Our ref: P/Gladmans/P190111/O

RE: P190111/O - Outline planning application for the erection of up to 120 dwellings with public open space, landscaping and sustainable drainage system (SuDS) and vehicular access point from the A44. All matters reserved except for means of access for Gladman Developments Ltd.

Highways Technical Note

Appendix A: Drawing FCL0041-01

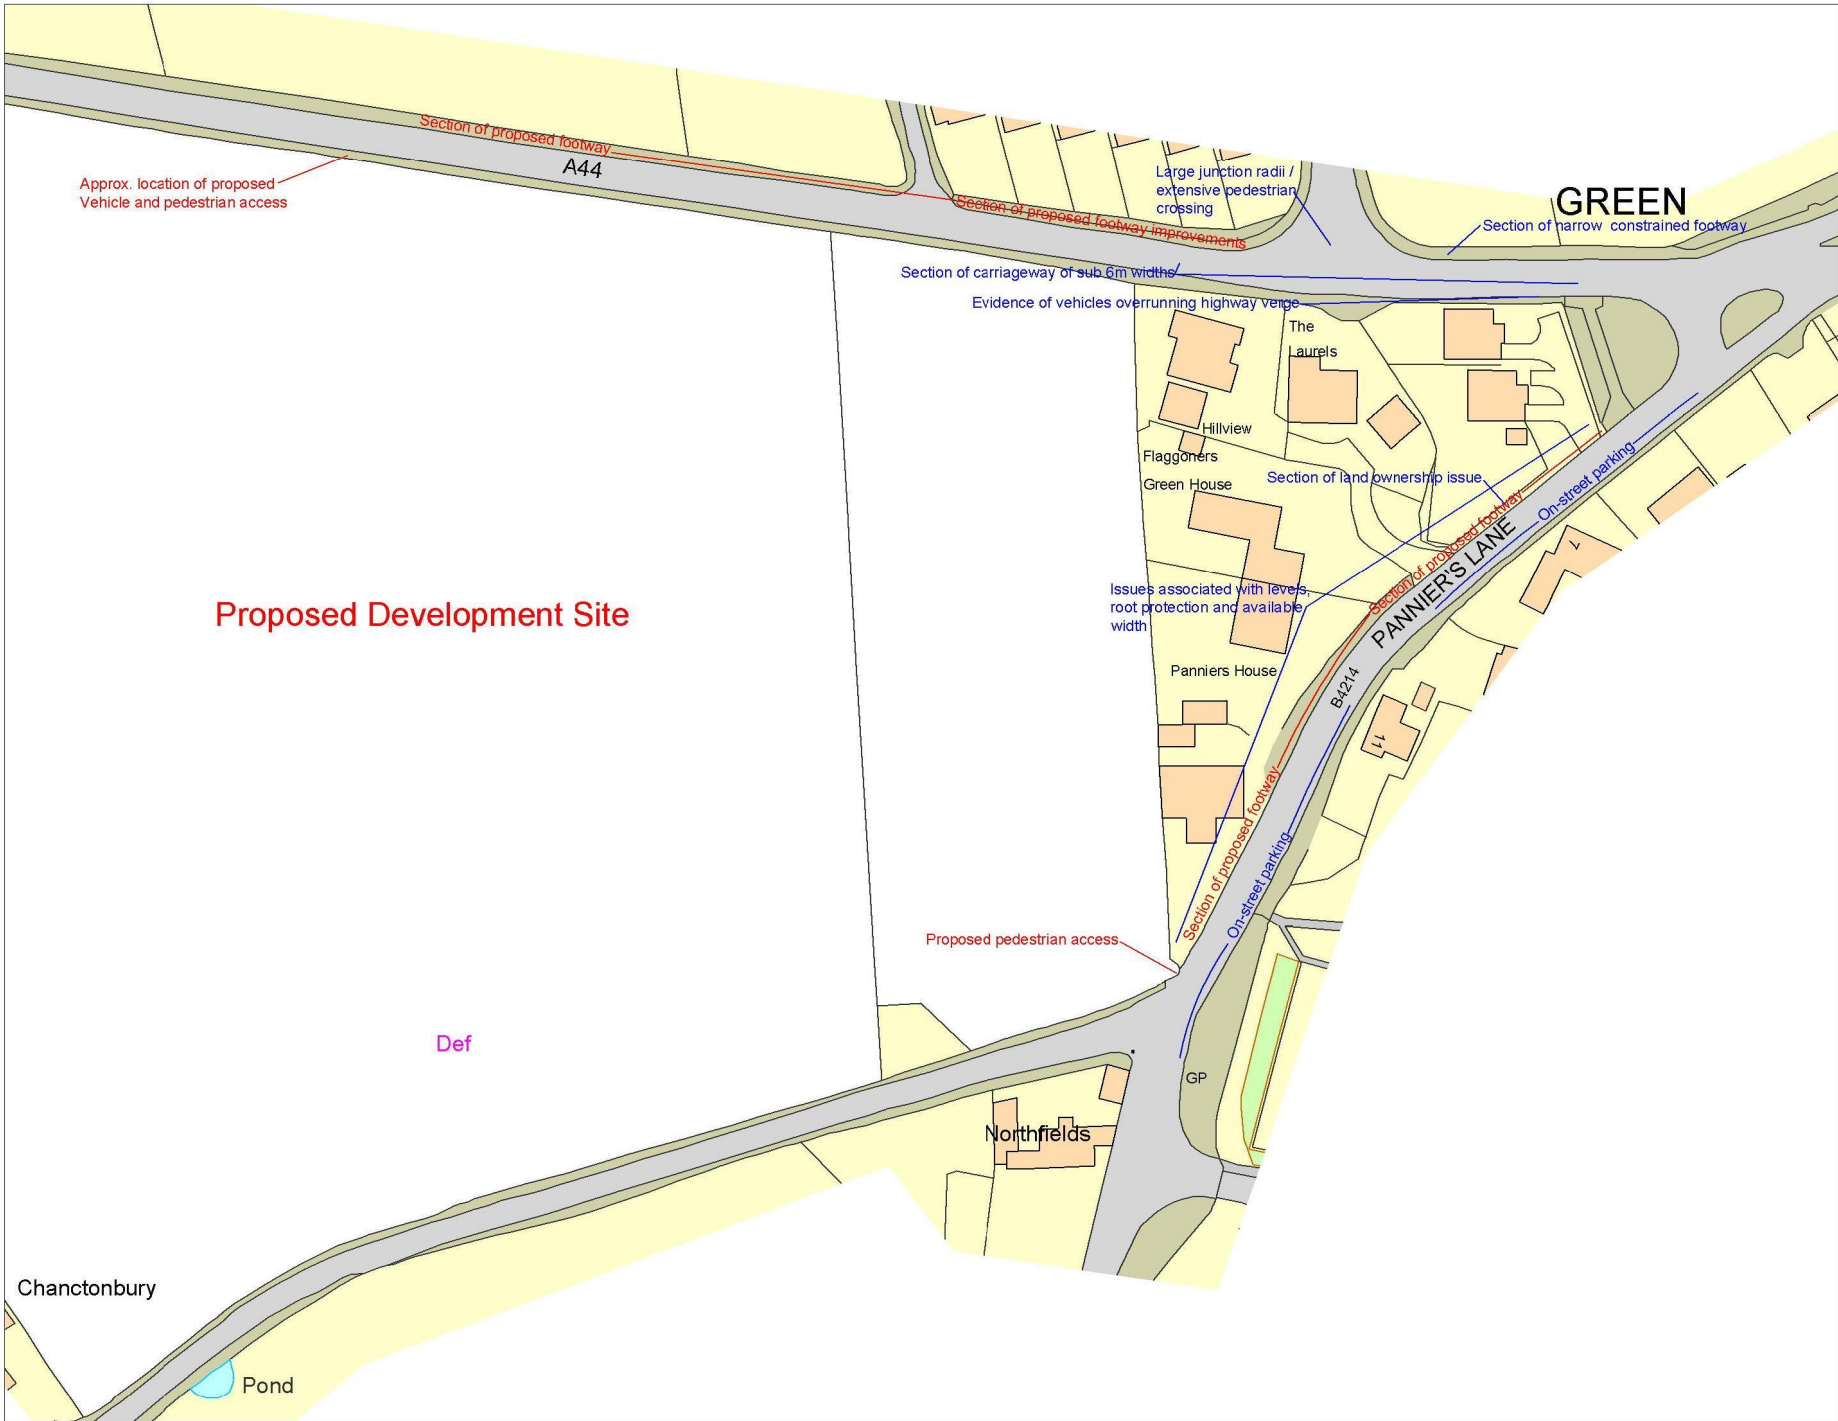
- 1.7 During the site visit and as part of a desktop-based assessment a number of issues, mostly highway safety related, have been observed and considered. The following provides a brief overview of three areas of issues identified prior to being assessed in greater detail:
 - ♦ **Issue 1:** Appropriateness of footway link along the A44 in consideration of highway conditions and character and associated highway safety issues. Also, the deliverability of an appropriate footway link and necessary improvements to adequately mitigate the issues.

- ♦ **Issue 2:** Deliverability of a sufficient footway link along Panniers Lane;
- ♦ **Issue 3:** General accessibility of the site in consideration of highway conditions, safety and local topography.

1.8 Drawing FCL0041-01, included as Appendix A, identifies the approximate locations of the issues raised.
